# Service Advisory

CC-509

Models Affected: RZT 42 (17AA5B4G709, 17AA5B4G710)  
RZT 50 (17AA5D7P709, 17AA5D7P710, 17AA5D7P756)

Subject: **Bypass Rod (747-04217C)**

**FIGURE 1.**

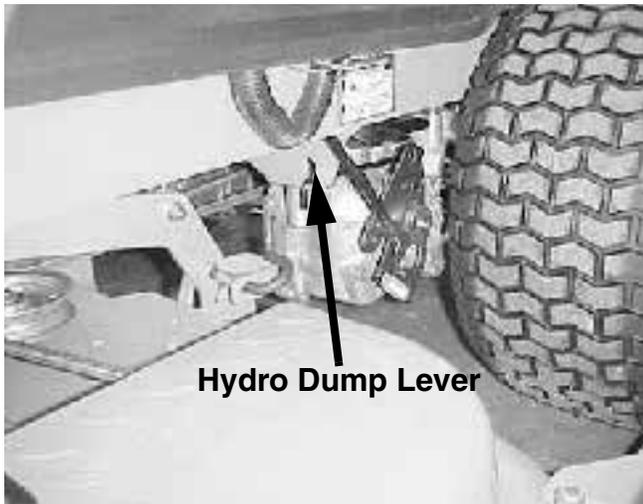
**PURPOSE:** To bring attention to the hydro bypass rod not being able to be released / activated when the cutting deck is in the highest position.

Lower the cutting deck to the lowest position. Locate the hydro bypass rod located on the left side of the unit, the dump rod faces the front of the unit with the lever facing down as shown in Figure 1.

Install the new 747-04217C bypass rod. Install a new cotter pin to secure the bypass rod to the bypass arm on the hydro transmission. Repeat the same process for the right hand side bypass rod. **NOTE:** The bypass rod on the right hand side will have the lever facing up.
